**Town of Addison
Engineering Review
Conditional Civil Approval**

STORM DRAINAGE
PLAN SD-1

ADDISON GALAXY FBO
15601 ADDISON RD.
PREPARED FOR
BLACK FOREST VENTURE

SHEET NUMBER
C12.02

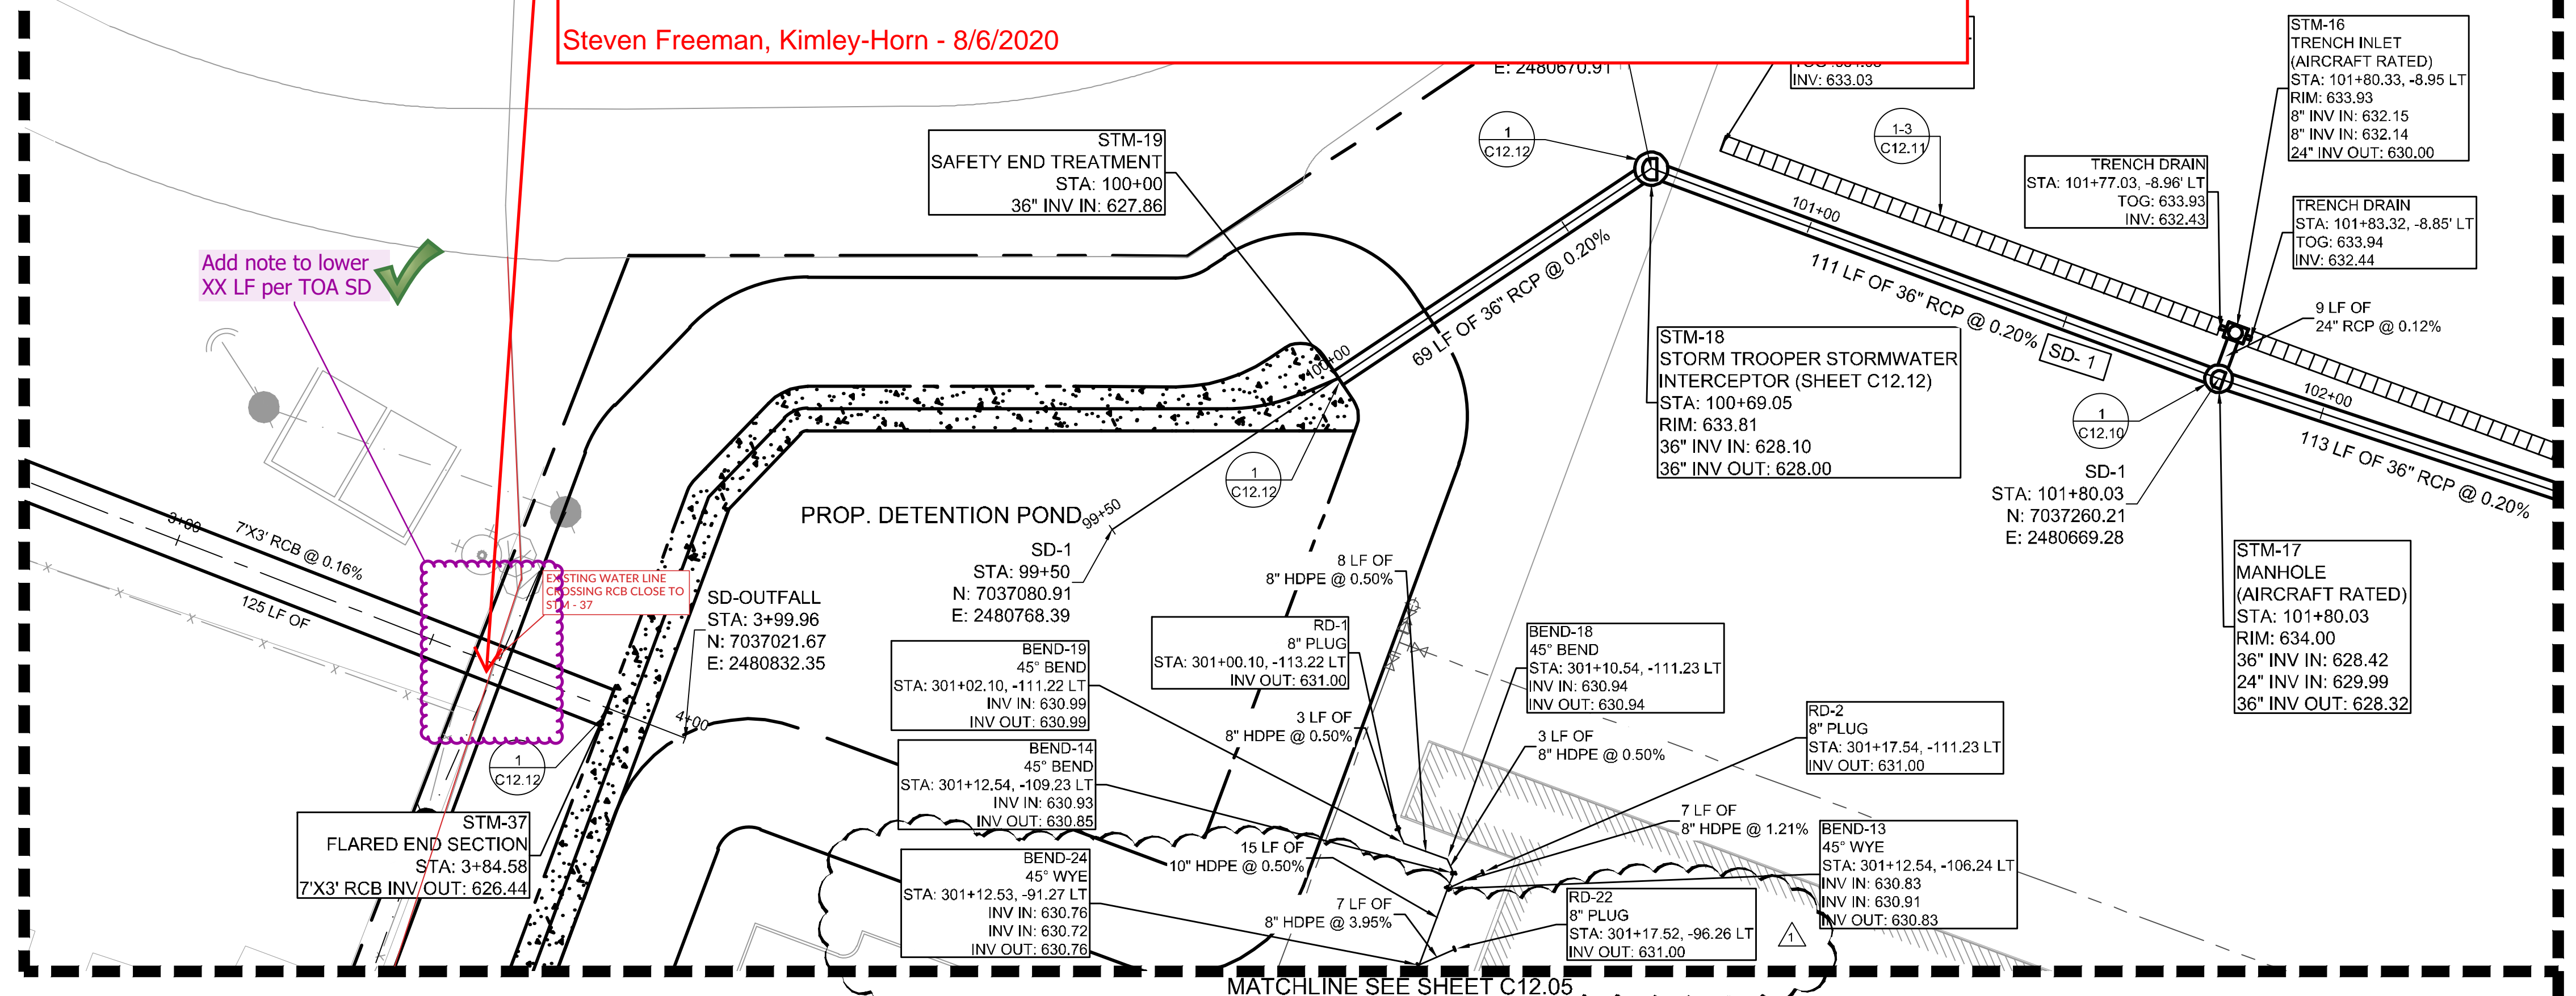
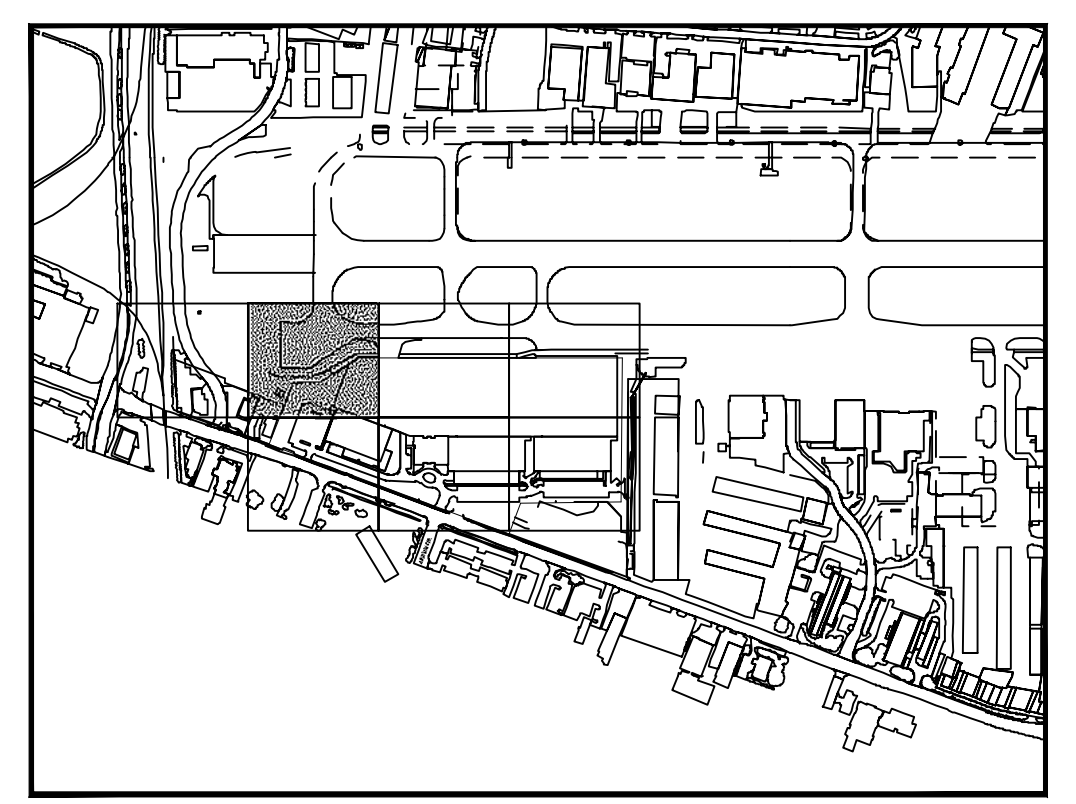
Lower a 10 LF section of the existing waterline (centered under the proposed 7' x 3' RCB) by a vertical distance of 6-inches so there is a minimum of 6-inches of clearance between the bottom of the RCB and the top of the lowered waterline section. Follow the Town of Addison standard "Water Main Lowering Detail" shown on this sheet to lower of the waterline with a pair of 45-degree vertical bends on each end of the 10 LF segment of the lowered waterline. Therefore, more than 10 LF of the existing waterline will need to be cut out and replaced so there will be a full 10 LF section of waterline pipe centered under the RCB that has 6-inches (minimum) of clearance from the bottom of the RCB.

Add note to lower XX LF per TOA SD

Steven Freeman, Kimley-Horn - 8/6/2020
